# HADITHA DAM PERIMETER SECURITY HADITHA, IRAQ

## SUSTAINMENT ASSESSMENT

**SIGIR PA-09-192**  
**APRIL 13, 2010**

SUBJECT: Report on the Haditha Dam Perimeter Security, Haditha, Iraq (SIGIR Report  
Number PA-09-192)

Figure 2. Contractor's design of typical fence section  
(Courtesy of GRC)

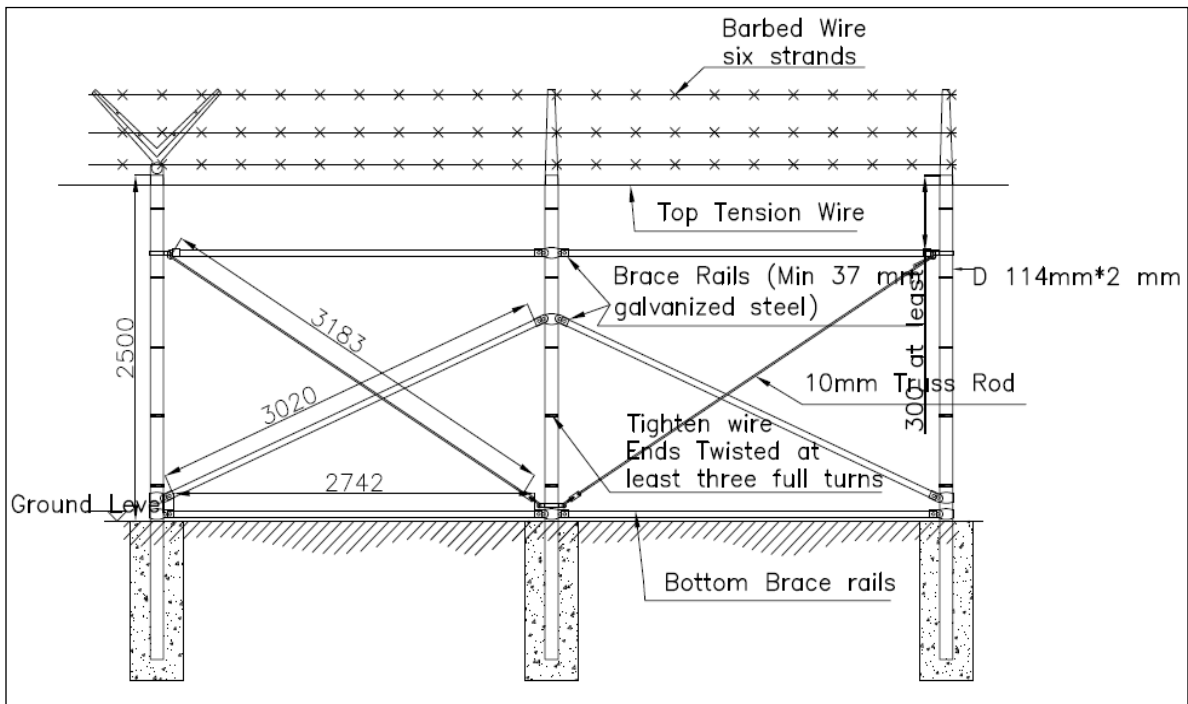
The contractor attached the chain link fabric to the fence posts with steel bands at 32 inches on center. The attachment did not conform to the 15 inches on-center requirement of the USACE standard drawings for a security fence, and was not consistent with the 18 inches on-center indicated on the contractor’s drawings.

The fence brace rails were different dimensions than shown on the contractor’s drawings. The brace rails were attached to the pull post approximately 36 inches above the post base, instead of 58 inches as shown on the contractor’s drawings. The difference will affect the ability of the brace panel to resist tension from the chain link fabric.

The concrete anchorage for the fence posts was approximately 8 to 12 inches deep (Site Photo 6), which was inconsistent with the contractor's design drawings that showed a 45 inch depth for a typical line post. The configuration of the concrete anchorage was not consistent with the contractor's design plans and tapered from approximately 16 inches in diameter at the top to 8 inches in diameter at the base of the post, instead of the required uniform diameter of 16 inches. In addition, the anchorage did not cover the end of the post as shown in the design drawings, which will allow for increased corrosion of the post.

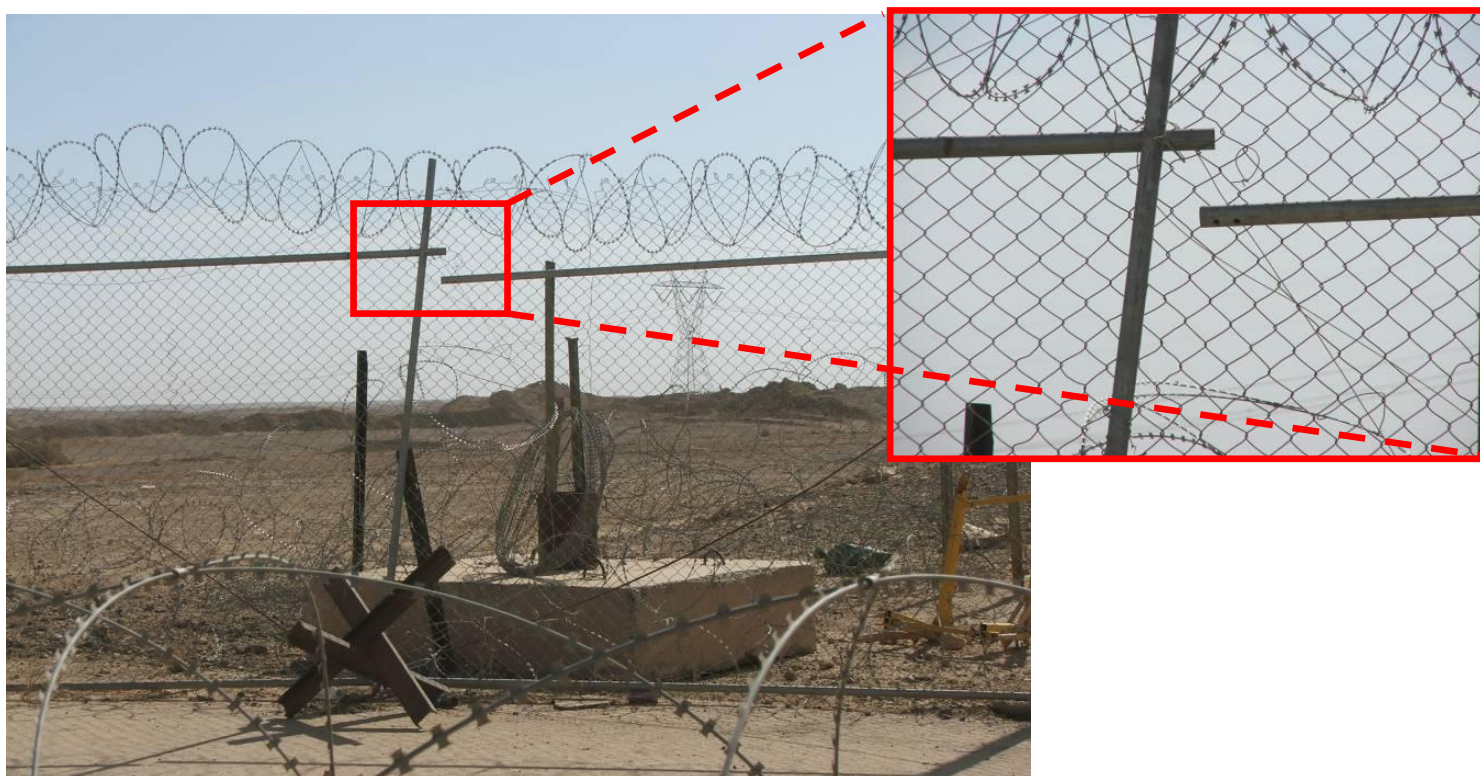
The entry point was constructed completely opposite of the contractor's submitted design plans. The contractor's plans indicated a reasonable method of controlling entry to the facility by using "Jersey" barriers and a lifting gate to slow vehicles prior to reaching the security fence. However, as constructed, vehicles first reach the swing gate in the security fence. After entering the secure area, vehicles are then confronted with the lifting gate, and finally directed through the chicanes into the facility. This configuration contributes little to force protection and allows vehicles to approach the secure area without any method to control speed or direction.
